From: Stan Sims <stan@stansimslaw.com>
Sent: Friday, November 11, 2022 2:09 PM
To: St Germain, Dante
Subject: Zoning Hearing at 4900 Hurstbourne Parkway (extending to Bardstown Road)

From: Madison Hicks <madisonhicksrealtor@gmail.com>
Sent: Thursday, September 22, 2022 9:32 AM
To: St. Germain, Dante
Subject: 22-ZONE-0012 and 22-ZONE-0076
Attachments: LD&T Meeting - 22-ZONE-0012 and 22-ZONE-0076.pdf

LD&T Meeting

22-ZONE-0012 & 22-ZONE-0076

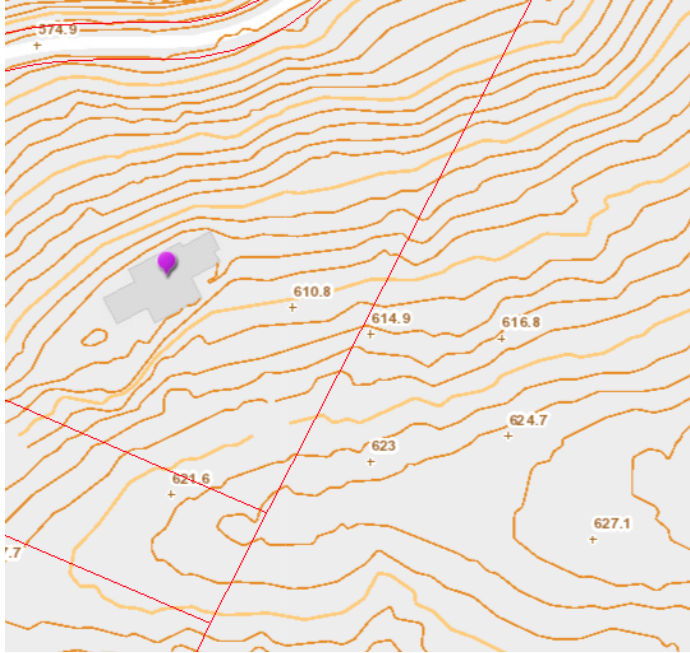
- According to section renderings, these massive 55-foot buildings are on land that is already 10 to 15-feet higher than adjacent properties. There may also be an additional 8-feet of backfill required (per geotechnical study and neighborhood meeting). Thus, these buildings will appear 78 feet to us who live below. See figure 3.1.

- For an *additional* 100-feet to be added to the setback along the North (Laurel Springs) and West (Walnut Hills Dr) sides of the property.
- Include a 6-foot berm with a 6-foot privacy fence and trees around the entire perimeter of the development at 4700 S Hurstbourne Pkwy and 4900 S Hurstbourne Pkwy.
- Leave the natural buffer along Laurel Spring Dr alone. See figure 3.4.

Figure 5.2 - Lojic Online's identification of steep slopes around proposed development.

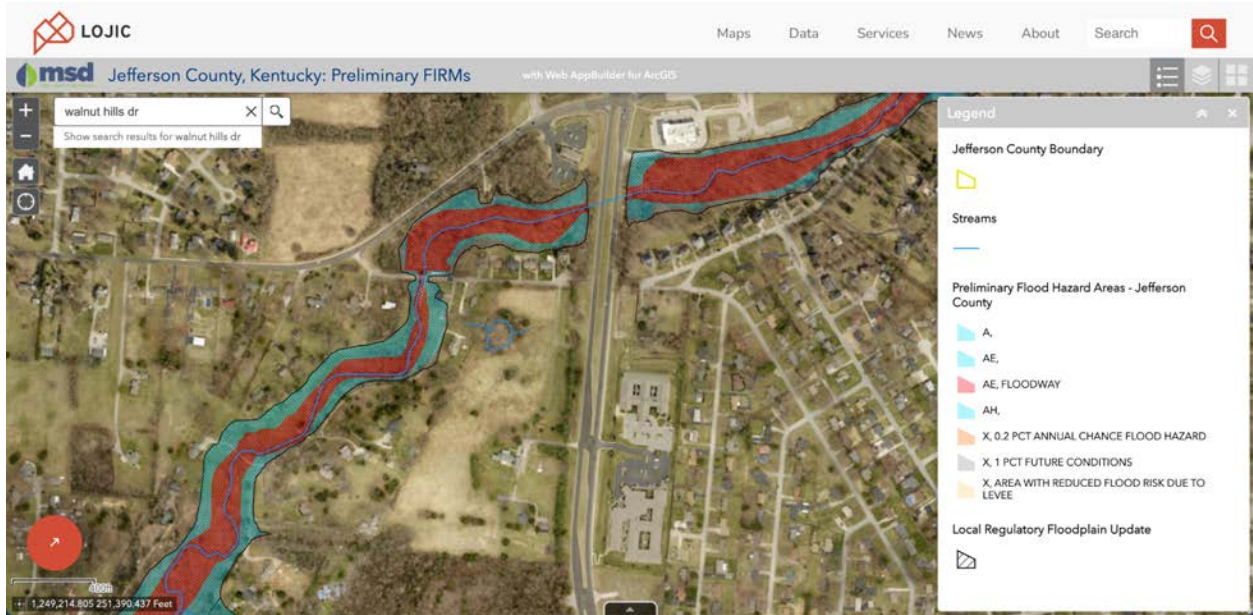
- According to Lojic Online, 4700 S Hurstbourne Pkwy is nearly surrounded by steep slopes, unlike any other development on Hurstbourne. See figure 5.2
- Due to our waterway being a FEMA Regulatory Floodway, surrounding properties are to be further regulated (according to FEMA). While the developer's property does not directly abutt to the creek, every single-family home surrounding it does. See figure 5.3

- For an unaffiliated third-party to conduct a geotechnical / impact study on the adjacent Walnut Hills and Laurel Springs properties.
